Proposed Cambourne to Cambridge Busway – Bin Brook Crossing and Impact on Clare Hall

Flood Risk Proof of Evidence – Graham Sinclair

Objector No: OBJ213

Inquiry Reference: TWA/24/APP/03

Figure 6.2: WSP Impact Grid 10m bridge at 1mm tolerance

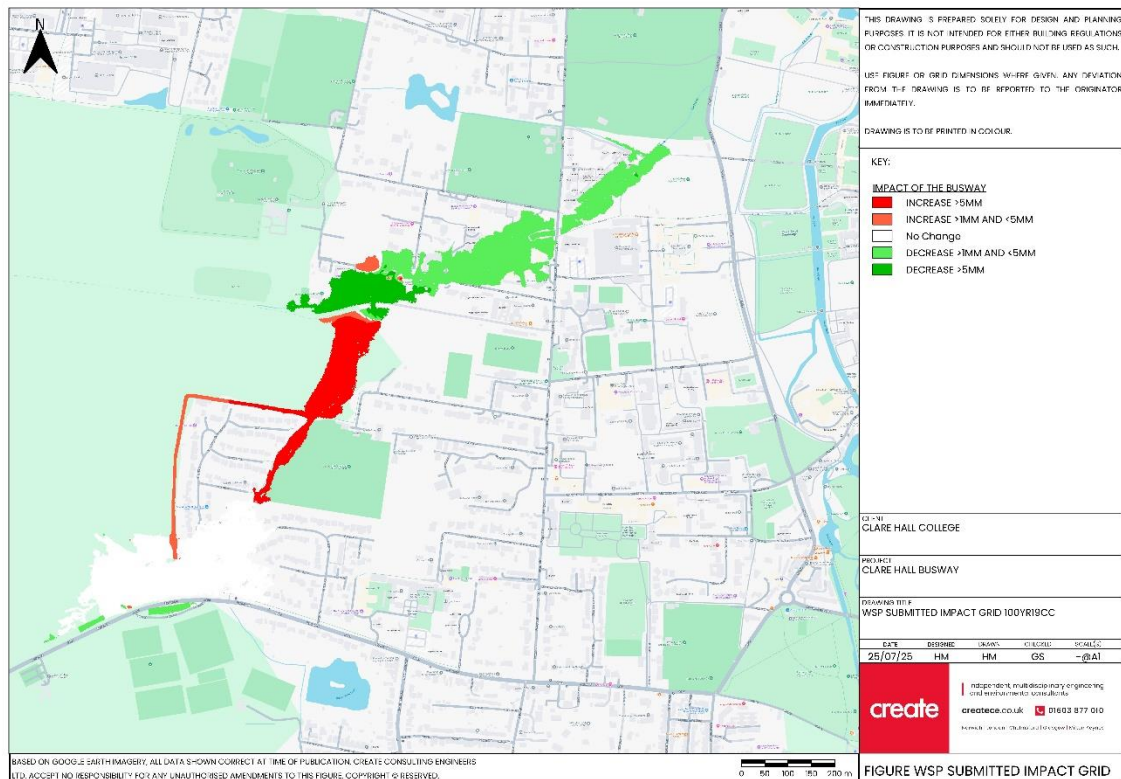
directly review the impacts. As anticipated, it is evident that there are offsite increases in flood risk within the Gough Way estate and to a lesser extent within Clare Hall itself. The impact grid is illustrated in Figure 6.2.

Figure 3.1: 1% AEP 19% CC impact of the proposed development on Flood levels

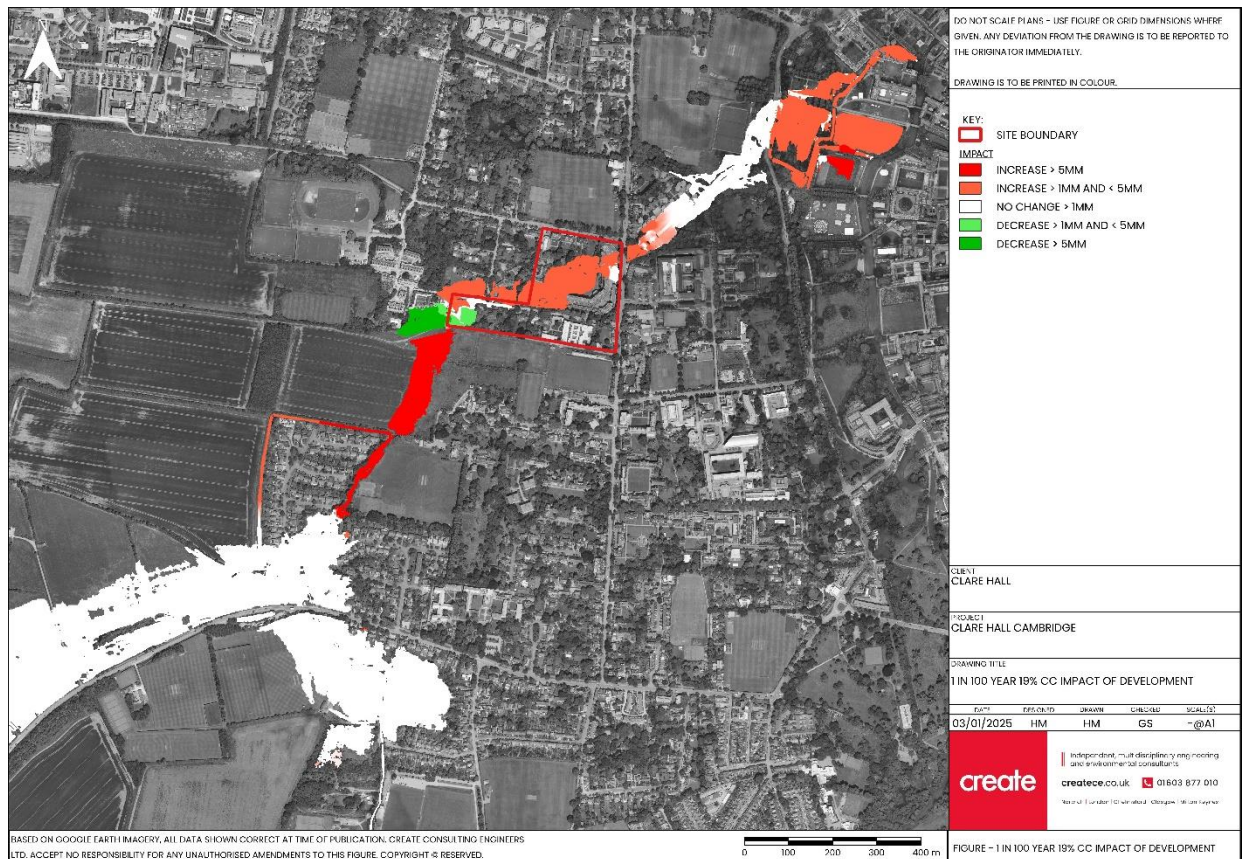
- 7.3 The results of the 2024 CCE Model indicate that when the development is tested in the latest model, and the tolerance is reduced to 1mm, there are offsite impacts observed in the results both upstream and downstream at each of the events studied as shown on Figure 3.

- 7.5 This is the result of the increased flow rates in the developed case interacting with the footbridge within Clare Hall, immediately downstream of the proposed busway bridge. This interaction is accentuating areas of increase that are noted in the WSP Modelling results downstream of the bridge structure.

- 8.10 With respect to the Exception Test, Paragraph 178 (b) of the NPPF (CD8-01) requires that it be demonstrated that the development will not increase flood risk elsewhere. However, Figure 7.1 of this proof of evidence shows that according to the independent CCE modelling, the proposed scheme would result in modelled flood impacts upstream and downstream for the 1% AEP plus climate change design event, indicating that flood risk is not contained within proposed development's red line boundary. Figure 6.1 further supports this analysis; this image was created using information received on 24 July 2025 and shows the WSP impact grids at 1mm tolerance. This image also shows offsite increases to flood risk. In addition we should not forget the significant increases in velocity discussed in Chapter 7.0 which also create increased flood risks as a result of the scheme. This is a direct contravention of NPPF paragraph 178 (b) and therefore the proposed development would fail the Exception Test.

Figure 7.2: 1% AEP 19% CC impact of the proposed development on immediate downstream velocity

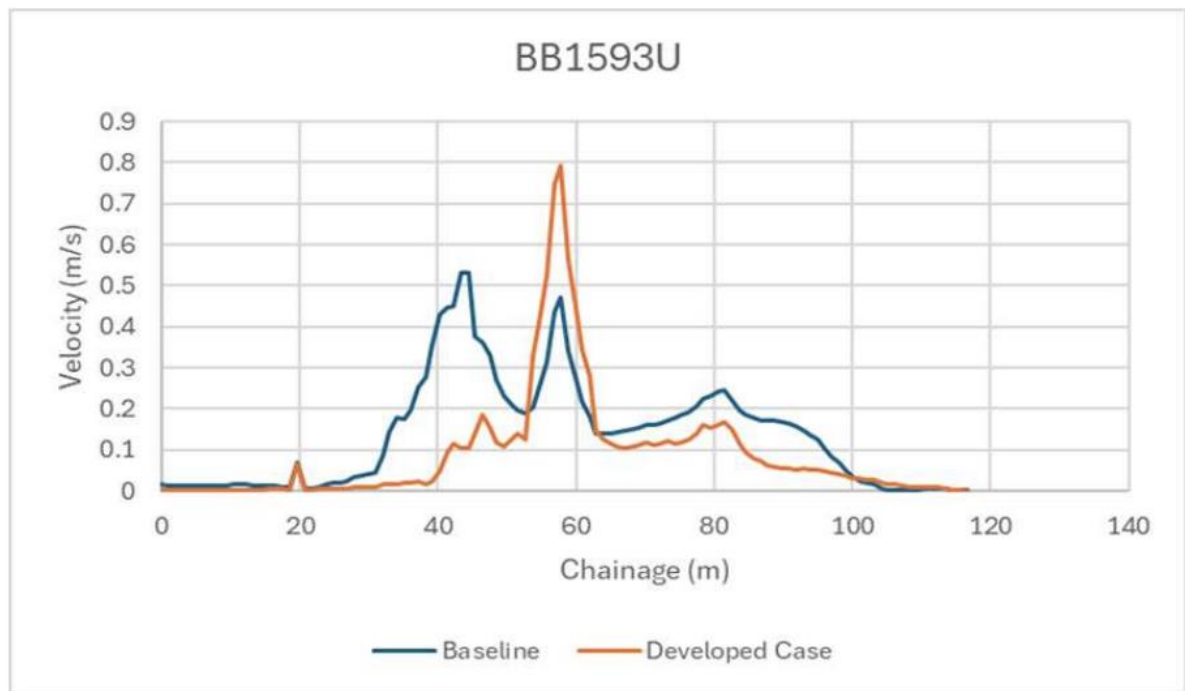
- 7.7 The independent CCE assessment included a review of the impact of the development on velocity. This assessment indicated that there was an increase in channel velocity by between 50 and 100% as a result of the development. For the design event this results in velocity increasing from 0.4m/s in the channel to 0.8m/s as shown on Figure .2. The impact of the development on velocity and flow rate through the structure is not discussed in the WSP report (CD1-11.13.02 Appendix TR13.1.1). These increases in offsite velocity are considered to be in contravention of guidance.

Figure 9.2: 1% AEP 19% CC impact of the proposed development on Flood levels with mitigation

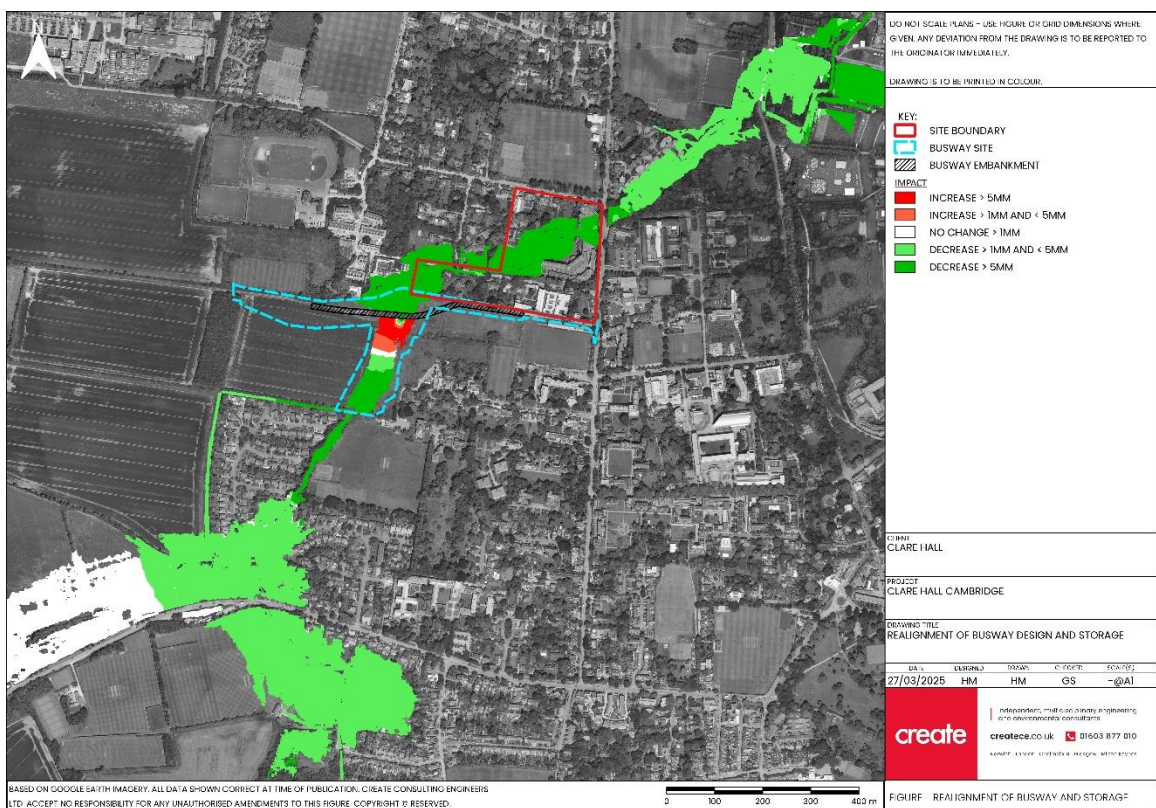
- 9.4 The mitigation design is shown in Figure 9.1: **CCE Proposed Mitigation Interventions**.¹ with the associated level impact in Figure 9.2: **1% AEP 19% CC impact of the proposed development on Flood levels with mitigation**.² and velocity impact in Figure 9.3: **1% AEP 19% CC impact of the proposed development on immediate downstream velocity with mitigation**. From these results it can be seen that the development is now demonstrating a net positive in regard to flood risk and flood levels within the catchment, with no offsite increases to flood levels and areas of decrease in flood risk.

Figure 9.3: 1% AEP 19% CC impact of the proposed development on immediate downstream velocity with mitigation

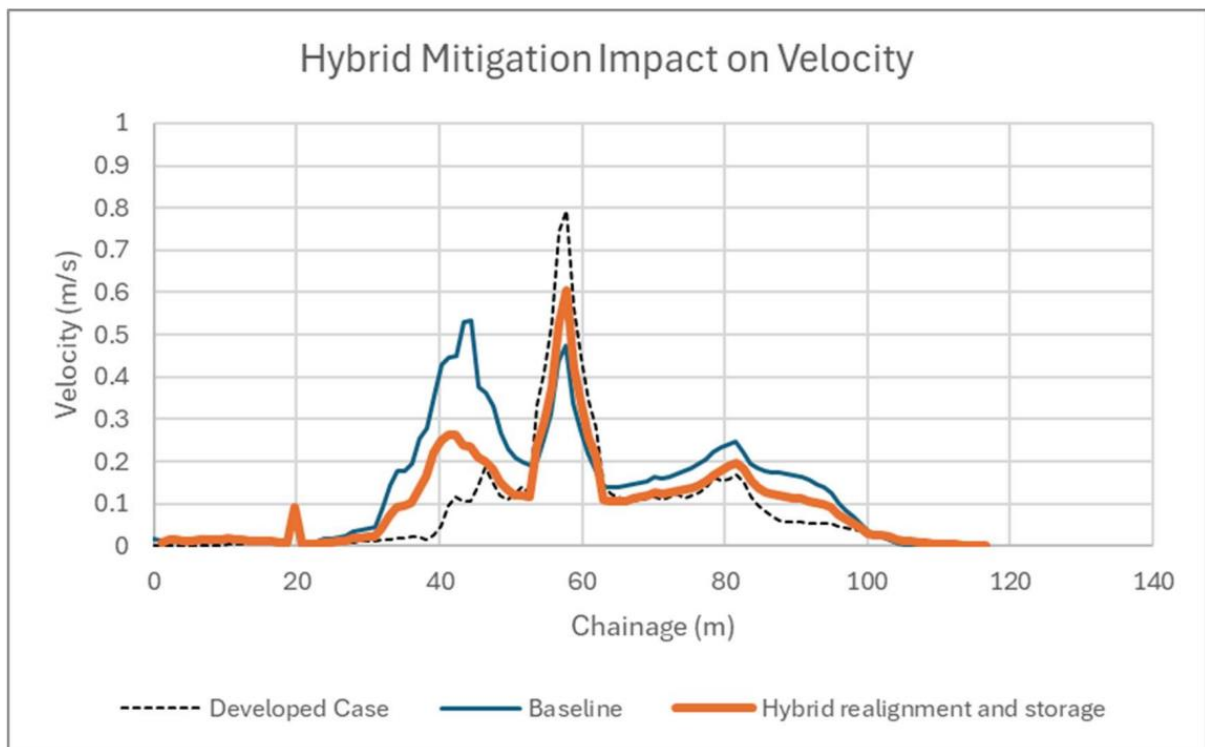
- 9.5 Regarding velocity, it can be seen in the Figure 9.3 that the realignment provides sufficient space between the proposed development and Clare Hall for the velocities to equalise much closer to the previous peak value, mitigating the impact of the development and reducing potential for additional offsite flow rates.
